OFFICE OF RIVER PROTECTION

SUBMITTAL OF HANFORD FACILITY RESOURCE CONSERVATION AND RECOVERY ACT PERMIT MODIFICATION NOTIFICATION FORM 24590-LAW-PCN-ENV-17-012

**Hanford Facility RCRA Permit Modification Notification
Form 24590-LAW-PCN-ENV-17-012**

Hanford Facility RCRA Permit Modification Notification Form
Part III, Operating Unit 10
Waste Treatment and Immobilization Plant

24590-LAW-M6-LOP-00001001

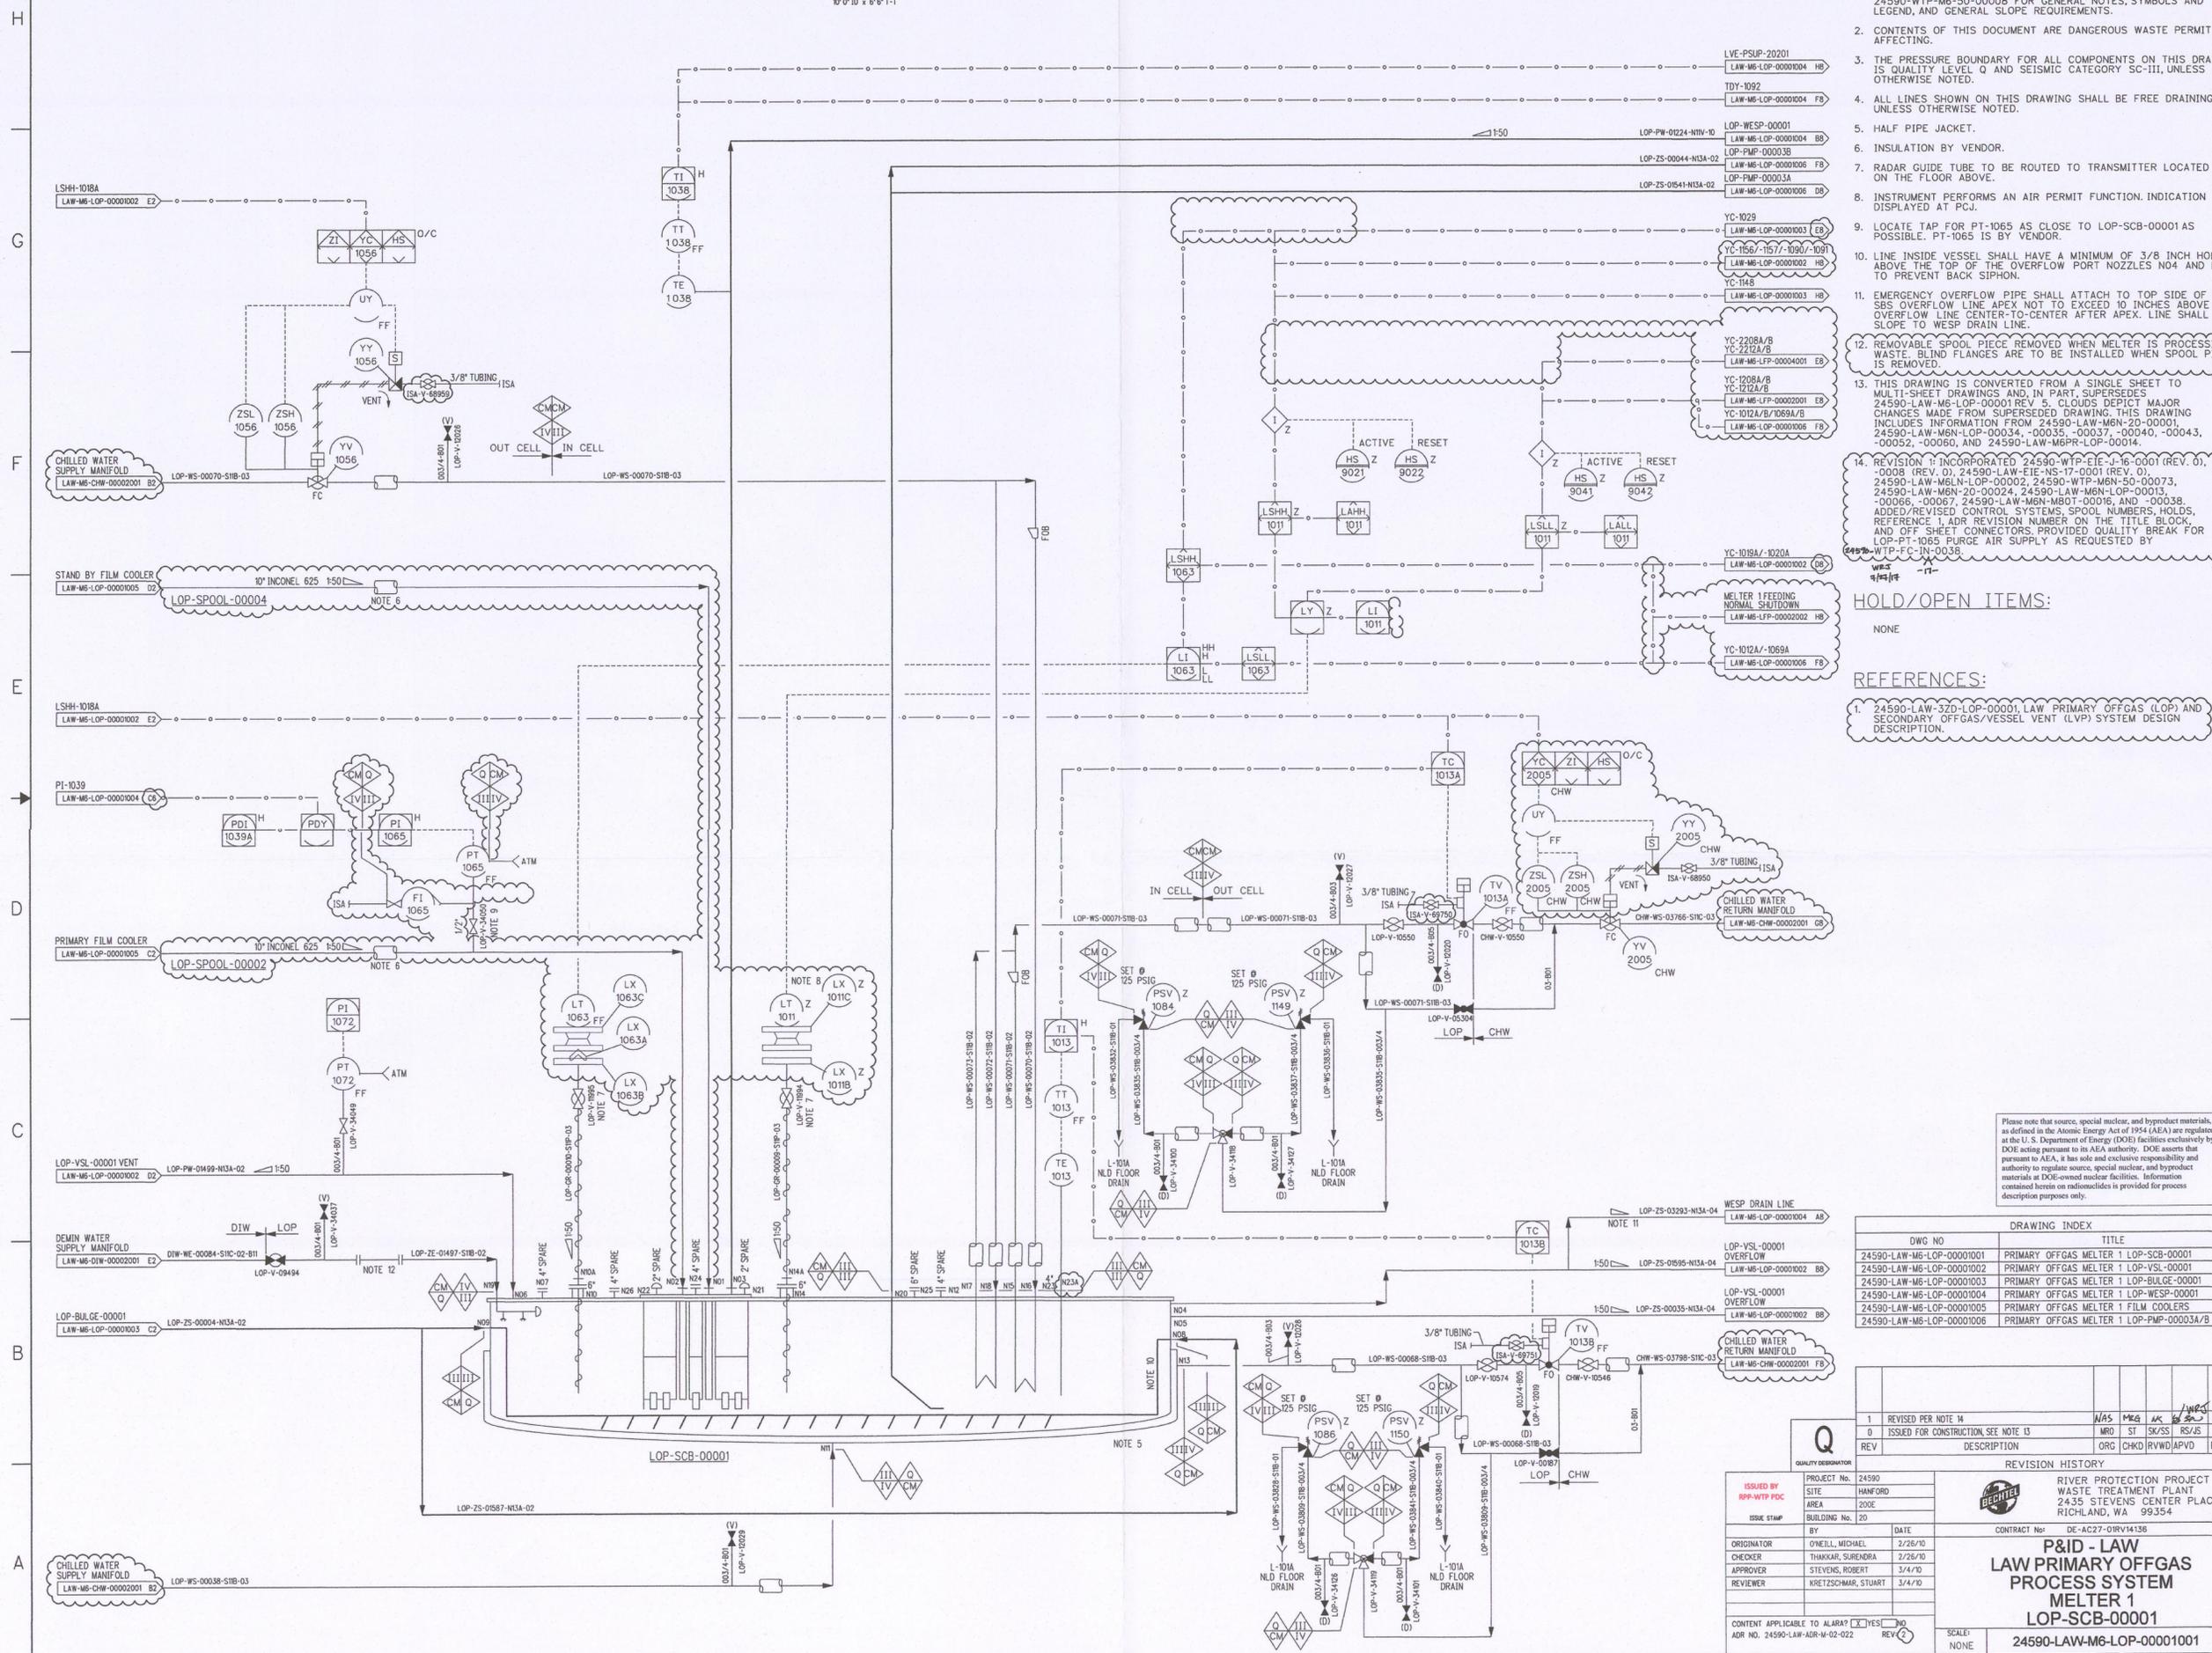
- Added the label "A/M" (auto/manual selector switch on operator display faceplate) for hand (manual) switches (Grids D5, D6, F7 and H7).
- Deleted instrumentation LOP-LSL-1018A (Grid E6).

- Moved off-sheet connector for level switch (high-high) LSHH-1011 and changed instrumentation control strategy by the addition, modification or deletion of instrumentation, lines, and valves (multiple grids).

- Revised graphical representation/depiction for remote radar level instrumentation LT-1018 (Grid C7).
- Changed valve symbol from gate valve to ball valve for ISA-V-68956, ISA-V-68957, ISA-V-69752, ISA-V-72509 and ISA-V-72510 (Grids B3, F6 to F7 and G6 to G7).

- Added seismic and quality flags for valves YV-1156 and YV-1157 (Grids F6 and G6).
- Updated the maximum operating volume for vessel LOP-VSL-00001 (Grid H5).

- Moved blind flanges closer to the nozzles (Grids B4 to B7).
- Added or moved piping labels closer to the nozzles (Grids B4 to B5 and C5 to C6).
- Changed valve symbol from 3-way ball valve to 3-way plug ball valve for ISA-V-34120 (Grid C3).

- Revised or moved off-sheet connectors (multiple grids).
- Incorporated changes from change documentation identified in the Notes section.

CONTRACT No.	REVISION HISTORY
DE-AC27-01RV14138	
	RIVER PROTECTION PROJECT WASTE TREATMENT PLANT 2435 STEVENS CENTER PLACE RICHLAND, WA 99354
	P&ID - LAW LAW PRIMARY OFFGAS PROCESS SYSTEM MELTER 1 LOP-WESP-00001
	24590-LAW-M6-LOP-00001004

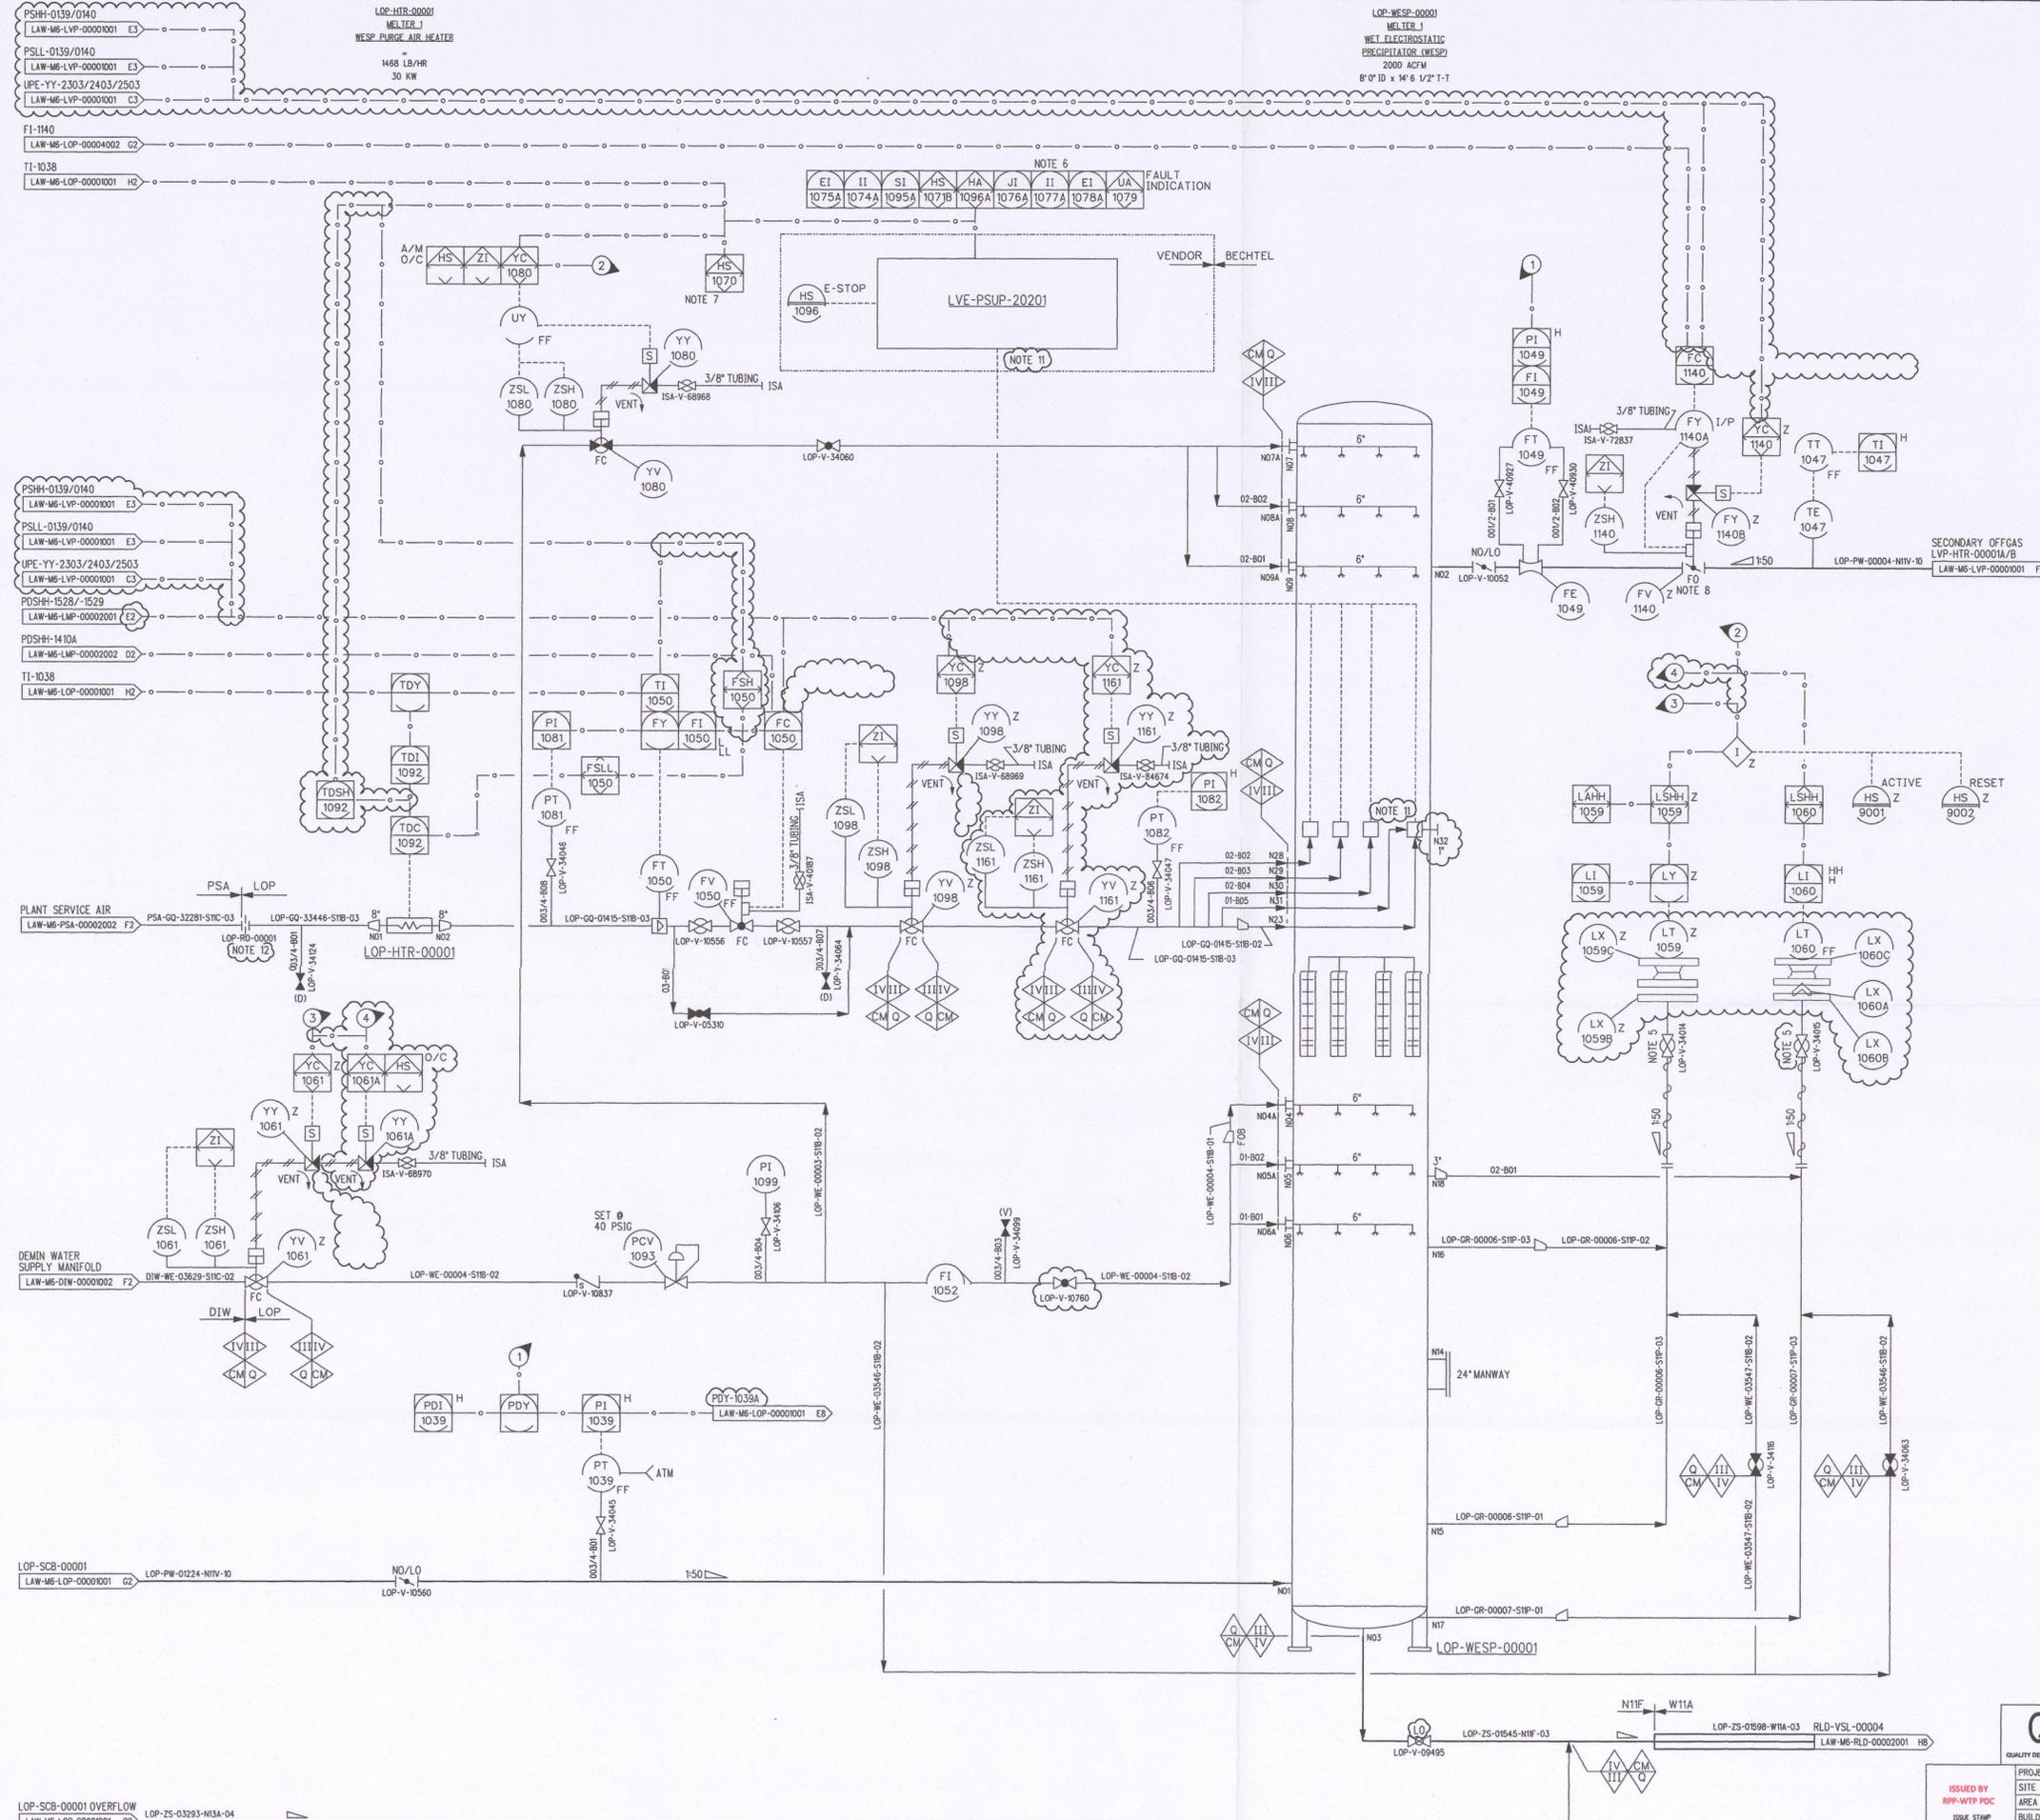
Changes to the P&ID (24590-LAW-M6-LOP-00001004, Rev. 2) for the Melter 1 Wet Electrostatic Precipitator (LOP-WESP-00001) are summarized below:

- Added or modified notes in the Notes section. Revised the References section.
- Revised graphical representation/depiction for remote radar level instrumentation LT-1059 and LT-1060 (Grid E3).
- Deleted seismic and quality flags near valves ISA-V-68969 and ISA-V-68970 (Grids D7 and E5).
- Added nozzle N32 (Grid E4).
- Added "locked open (LO)" label for valve LVP-V-09495 (Grid B4).
- Revised instrumentation control strategy by the addition of instrumentation, lines, and valves (multiple grids).
- Changed valve symbol from ball valve to globe valve for LOP-V-10760 (Grid C5).
- Added or revised off-sheet connectors (multiple grids).
- Incorporated changes from change documentation identified in the Notes section.
